MODIFYING A WC INPUT FOR PROPER GPS LEVEL

MODIFYING A WORD CLOCK INPUT FOR LOW LEVEL SOURCE

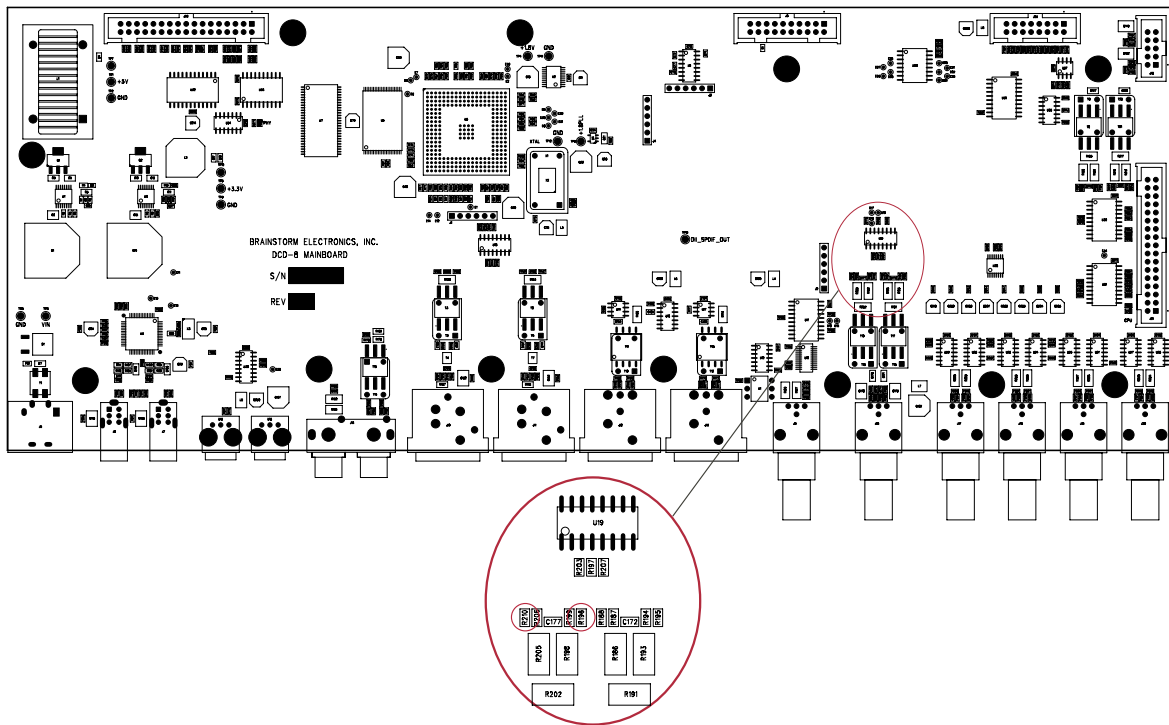
However, if the level of the GPS becomes too low to be accepted by the DCD-8, 2 resistor values can be changed so that the required level would only be 0.59Vp-p.

Locate R196 and R210. Normal value for both resistors is 4.7K Ω .

Replace them by 10.5K Ω resistors.

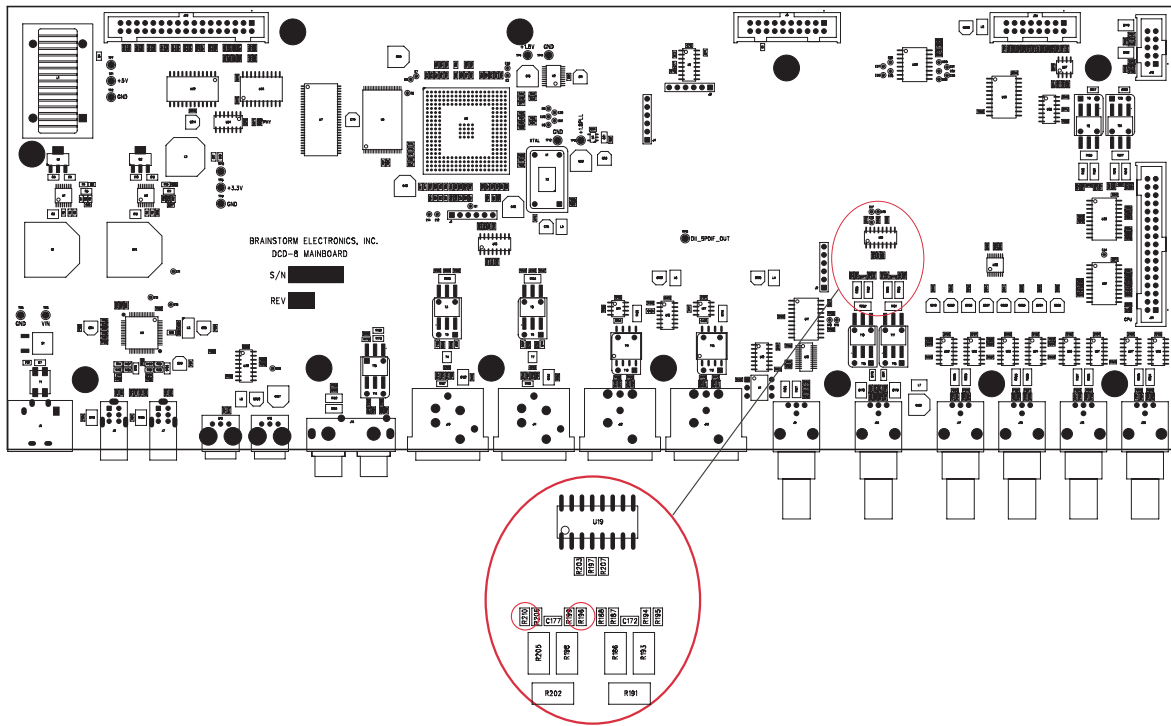
For those situations, 2 resistors can be removed, changing the minimum required input level to 0.20Vp-p.

Typically, we would recommend modifying WC Input 2 only, leaving the other 2 inputs unchanged so that they are less susceptible to noise.

- locate R196 and R210. Normal value for both resistors is 4.7K Ω .
- Remove those resistors.

Inputs 1 & 3 can be modified the same way. The resistors to remove for those inputs are:

- INPUT 1: R188 & R195
- INPUT 3: R214 & R221
